SOQUEL APTOS GROUNDWATER MANAGEMENT COMMITTEE (SAGMC)

AGENDA

To: Ron Duncan, Soquel Creek Water District
From: Cameron Tana
Cc: Ralph Bracamonte, Central Water District
Rosemary Menard, City of Santa Cruz
John Ricker, County of Santa Cruz
Date: January 15, 2016
Subject: Santa Cruz Mid-County Basin Boundary Modification Update

Santa Cruz Mid-County Groundwater Basin Boundary Modification

Figure F - 2: Gravity Anomaly Data and Granitic Basement Contours in Vicinity of Purisima Mutual Water Company

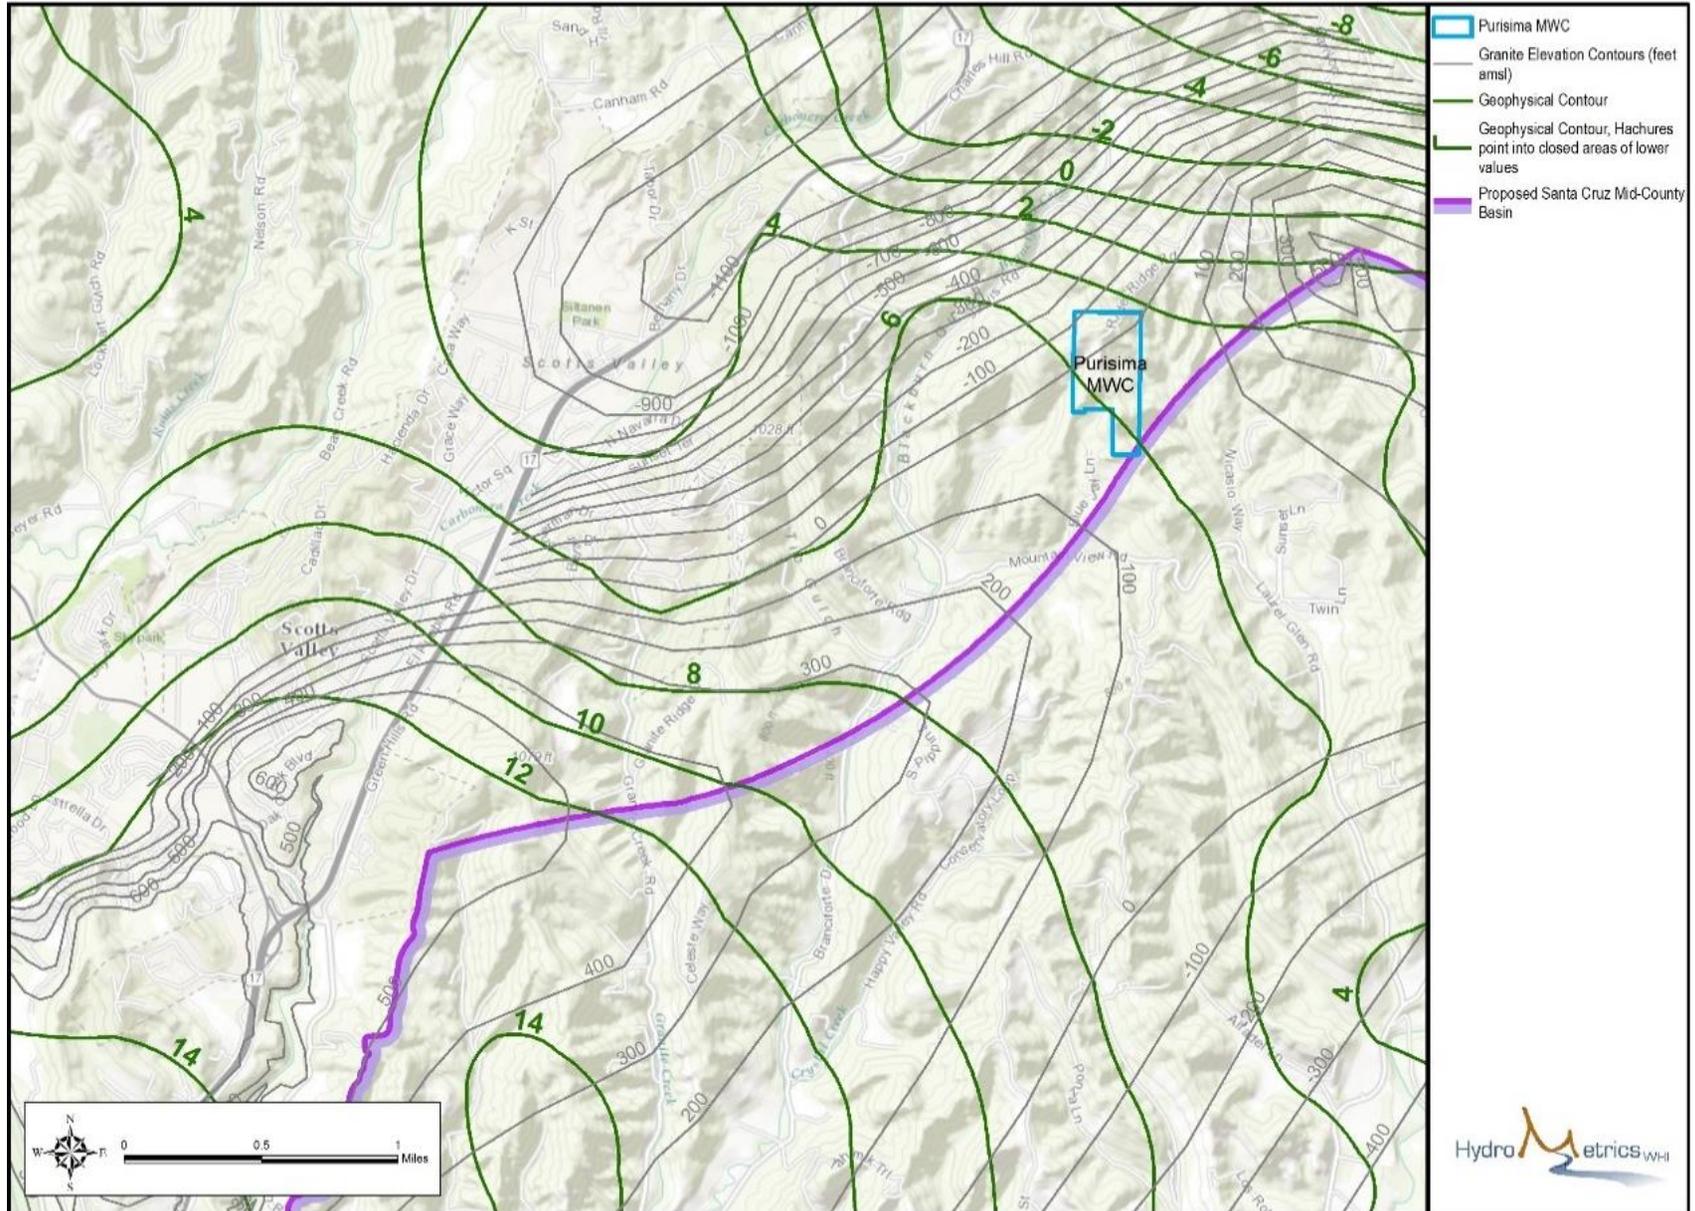
Point 5-2: "...if the gravity anomaly map (Figure 8 of the Scotts Valley report) were to be interpreted correctly one would see that inclination for water transport would be towards Soquel and not toward Scotts Valley..."

Point 5-3B "...the top of the granite map (Figure 11 in the Scotts Valley report) also shows that the surface of the granite dips toward Soquel (south) at the location of the Purisima Mutual Water Company's water well..."

Refer to the response to Point 5-2 and Figure F - 2.

Figure F - 3: Surface Geology and Watershed Area in the Vicinity of Purisima Mutual Water Company Figure 13: Surface

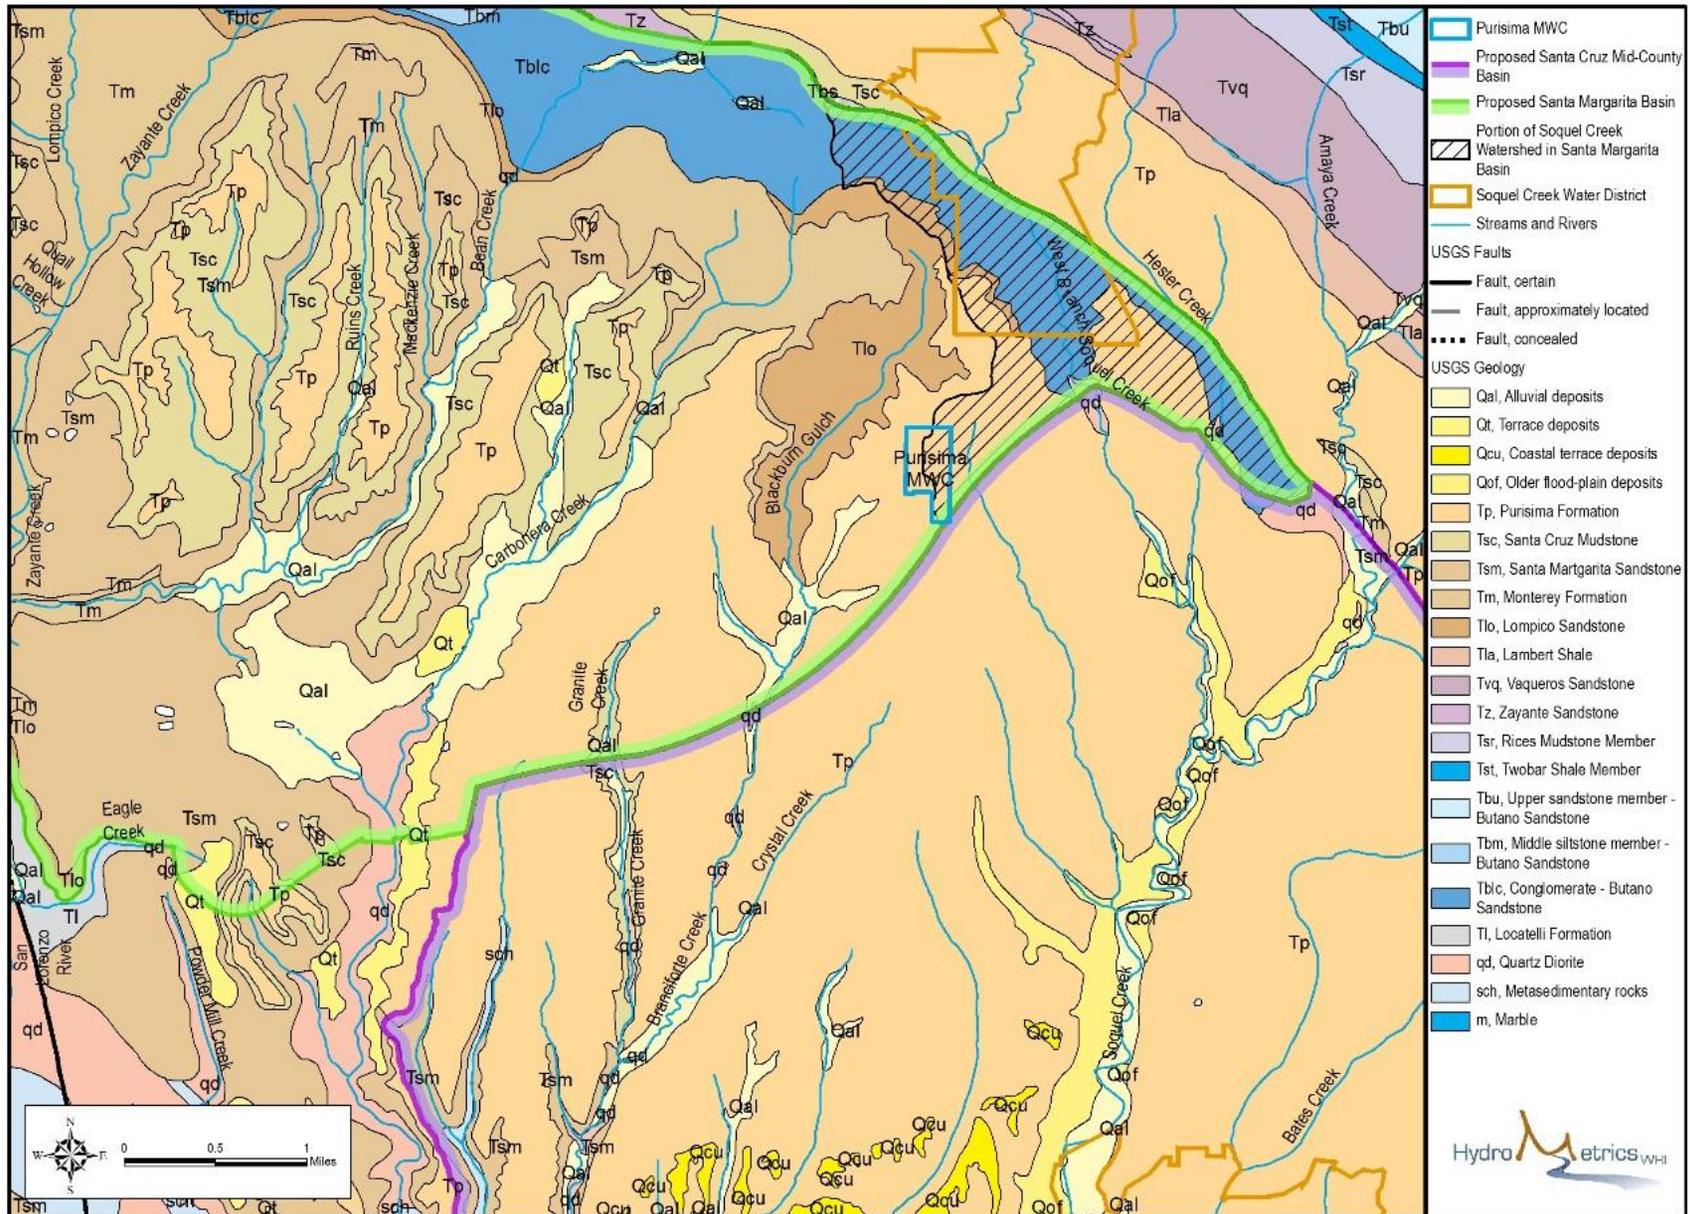
Point 5-5: "...the Soquel-Aptos Groundwater Plan Management Area shown in Figure 11 of the Mid-County report makes much more sense as a basin boundary than that proposed by the Scotts Valley report. The smooth arc-like change shown from the proposed boundary adjustment makes no geological sense..."

Figure F - 3 shows the Purisima Mutual Water Company's service area with respect to surface geology and the local Soquel Creek Watershed boundary. This figure indicates that Purisima Mutual Water Company overlaps two watershed areas. In the north and west of the company's service area, surface water or shallow groundwater may flow towards Blackburn Gulch, where a large area of the Lompico Sandstone is outcropping. As such, recharge to groundwater in Blackburn Gulch is more likely associated with the Santa Margarita Basin. We acknowledge the potential for runoff or recharge to the Santa Cruz Mid-County Groundwater Basin from Purisima Mutual Water Company's service area, as well, but inclusion of the company within one basin or another based on watershed area was not a consideration when drawing the proposed boundary.
